GE Nuclear Energy

MFN 050-96
Docket No. 52-001

ABWR Design Change Assessment Review of FOAKE Design Changes

PROPOSED CHANGES

FIGURE 4.6-9 CONTROL ROD DRIVE SYSTEM PFD (Sheet 1 of 1)

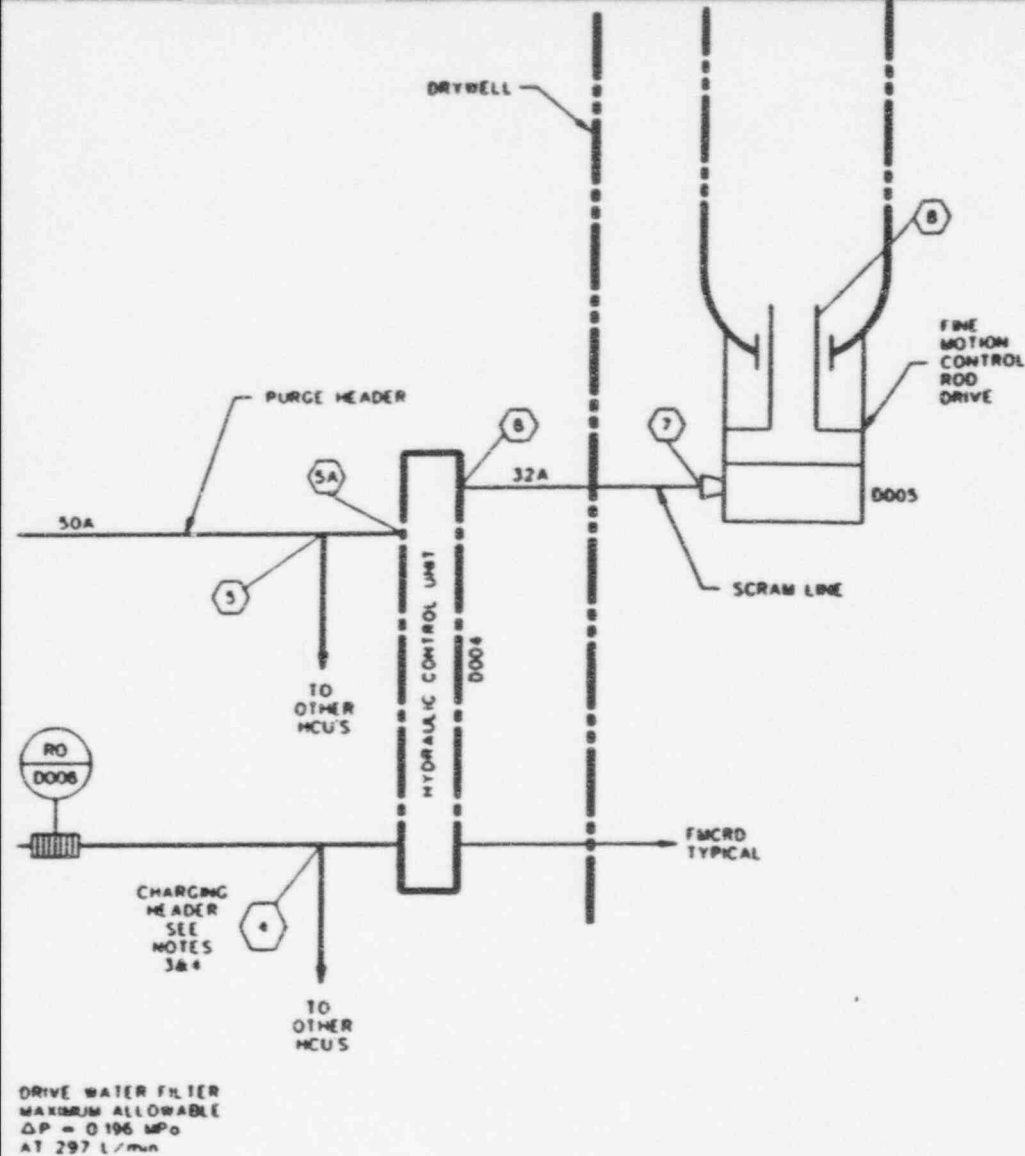
**Increase FMCRD Scram Piping
Design Pressure**

Replace both
with
"23.5"
